**TITLE:** **SPECIAL PERMIT NO. 1845, STONE BRIDGE CREEK COMMUNITY UNIT PLAN**, requested by Hampton Development Services, for 437 dwelling units, with associated waiver requests, on property generally located between North 14<sup>th</sup> and North 27<sup>th</sup> Streets, north of I-80 and south of Alvo and Arbor Roads.

## **LINCOLN/LANCASTER COUNTY PLANNING STAFF REPORT**

**P.A.S.:** Stone Bridge Creek  
Annexation No. 00003  
Change of Zone # 3265  
**Special Permit # 1845**  
Preliminary Plat #00017  
Use Permit # 139

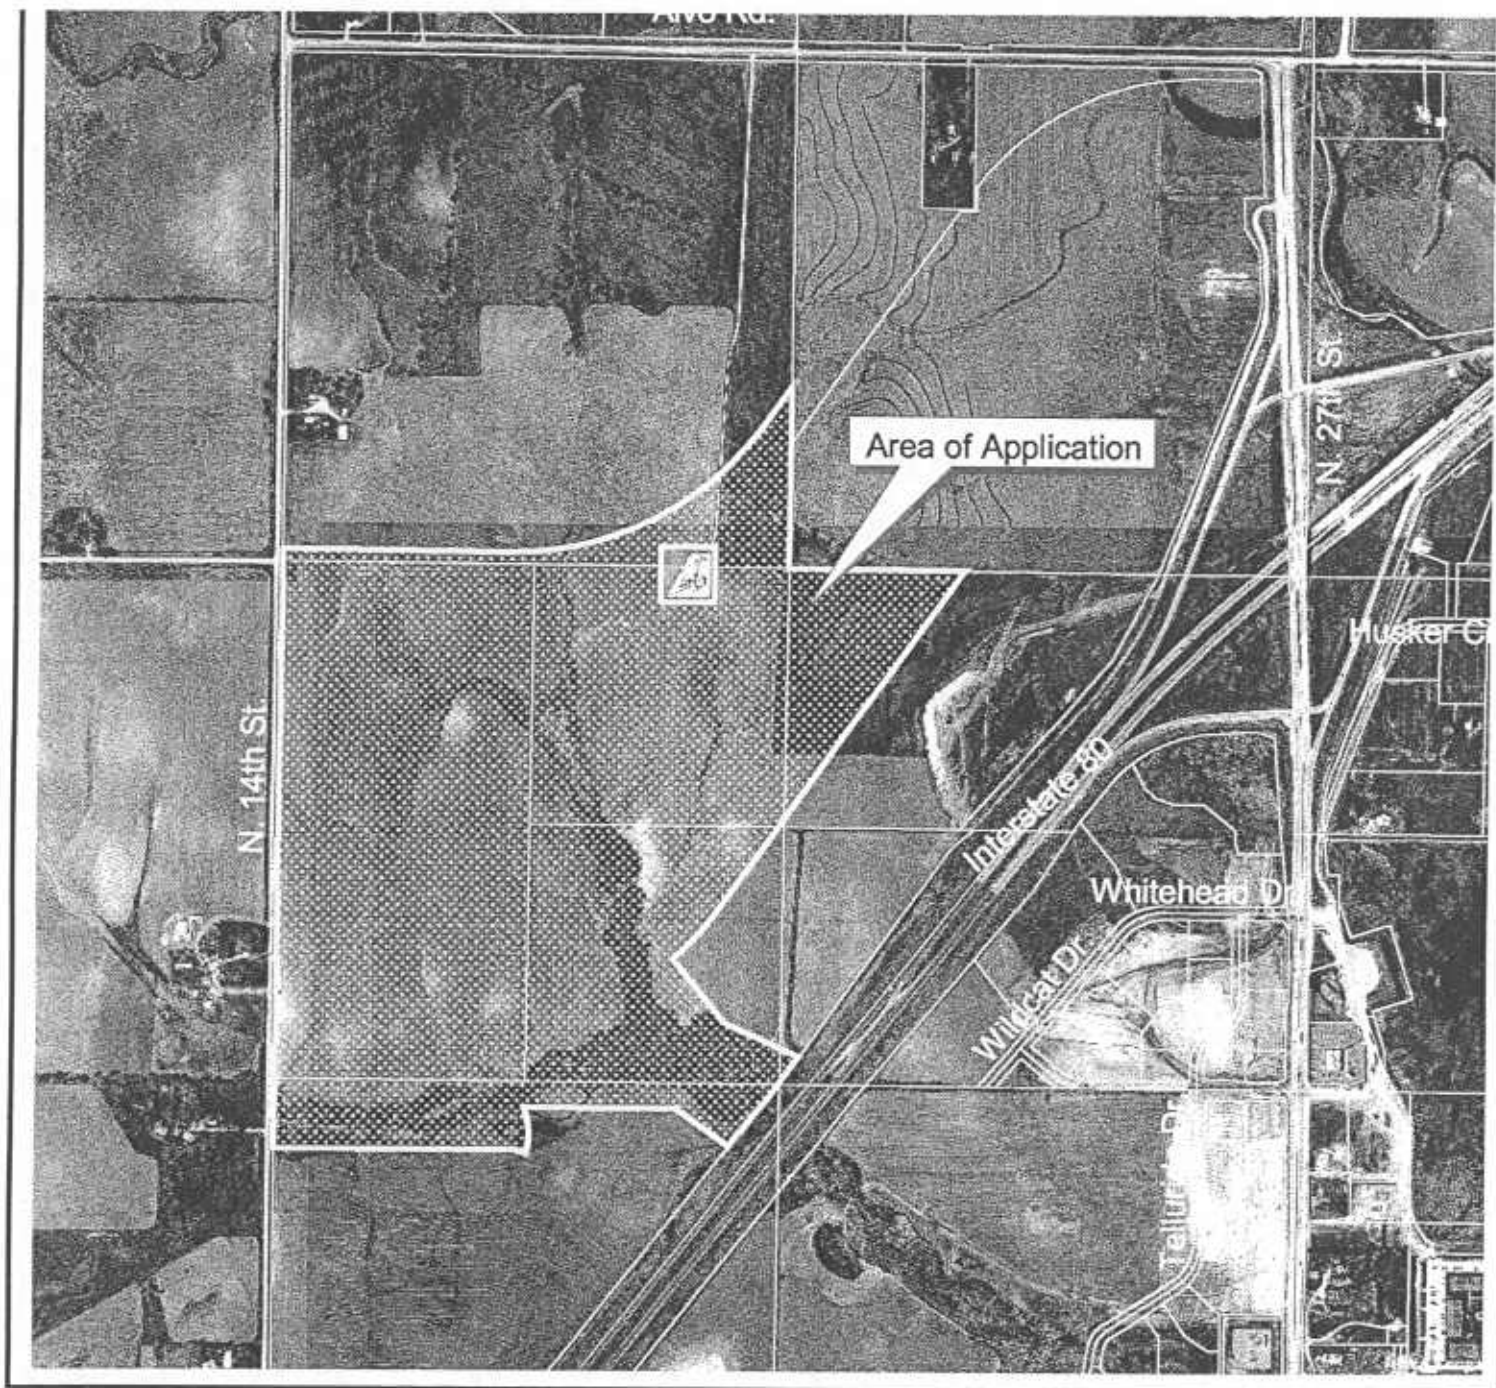
Hunzeker stated that this development is dedicating 120' of right-of-way on Alvo Road, and the initial construction of that road is a single lane on either side of a large median with turn lanes at every intersection. A median is designed to be wide enough to allow dual left turn lanes at all those intersections if it becomes necessary. Even if the traffic engineers are wrong and there is a need to signalize<sup>3</sup> the intersection that we are being asked to move, there is enough room to provide

dual left turn lanes and still have 600-700 feet of dual left turn lane at 14<sup>th</sup> and Alvo/Arbor Road. We're not going to interfere with that intersection.
